ENGINE - HP COMPRESSOR DISCS - INTRODUCTION OF A REWORKED STAGE-3 TO 8 DISC ASSEMBLY
WITH REVISED L SHAPED SEALING WIRES - CATEGORY CODE 6 - MOD.ENG-72-0304

V2500-ENG-72-0304

Part section through the HP Compressor Stage-3 to 8 drum
Fig.1

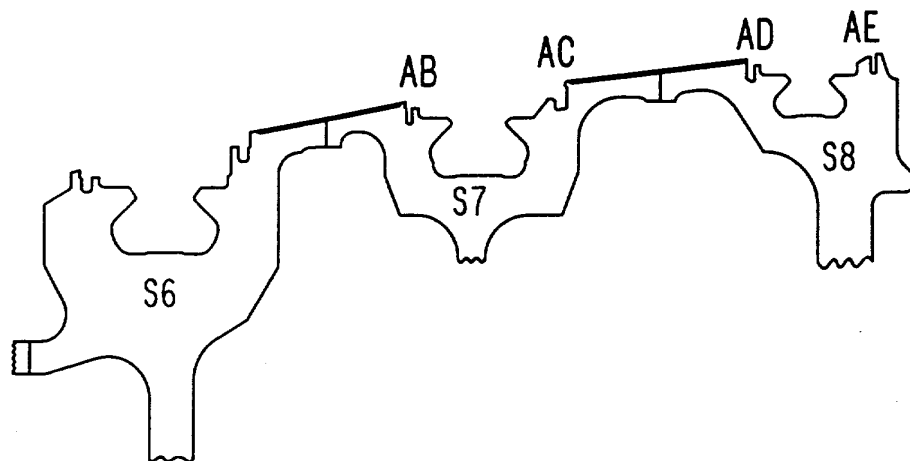
Fretage on the side faces of the Stage-7 rear and Stage-8 front sealing slots of the HP Compressor Stage 3-8 drum assembly, can occur.

The problem is caused by too much tolerances of the axial positions of the slots, together with circumferential movement of the wires. This results in too much wear of the slot side faces.

(a) The sealing wires for the Stage-7 rear and Stage-8 front have changed as follows:

(i) The sealing wires are 'L' shaped. This gives an increased contact area between the wire and the bottom of the blade platform.

(i) The slots for the Stage-7 rear and Stage-8 front sealing-wires have changed so that the new sealing wires can be installed.

Use IAE 3R18735 turning arbour, 1 off, with centre lathe. Use a dial test indicator to make sure the disc assembly runs true. Make sure datum's A, B and C run true. (Refer to Figures 1 and 2).

- (c) Set up the dimension from Datum A within the tolerance band of 1.098 in. (+/- 0.004 in.) (27,89 mm (+/- 0,1 mm)). This is to clean up the front face of the Stage-7 rear damping wire slot. Do not remove more than 0.002 in. 0,05 mm) of material from this face.

- (d) Machine the new profile at the front of the Stage-7 rear damping wire slot and the rear of the Stage-8 front damping wire slot.

Use IAE 3R19079 front groove tool 1 off. Use a turning speed of 114.8ft (35m.) per minute, with a feed of 0.002in. (0,05mm.) per revolution. (Refer to Figures 1, 2 and 3)

NOTE: Do not machine to the full dimensions of the slots. An allowance of 0.005 to 0.010in. (0,127 to 0,254mm.) for the final machining is necessary.
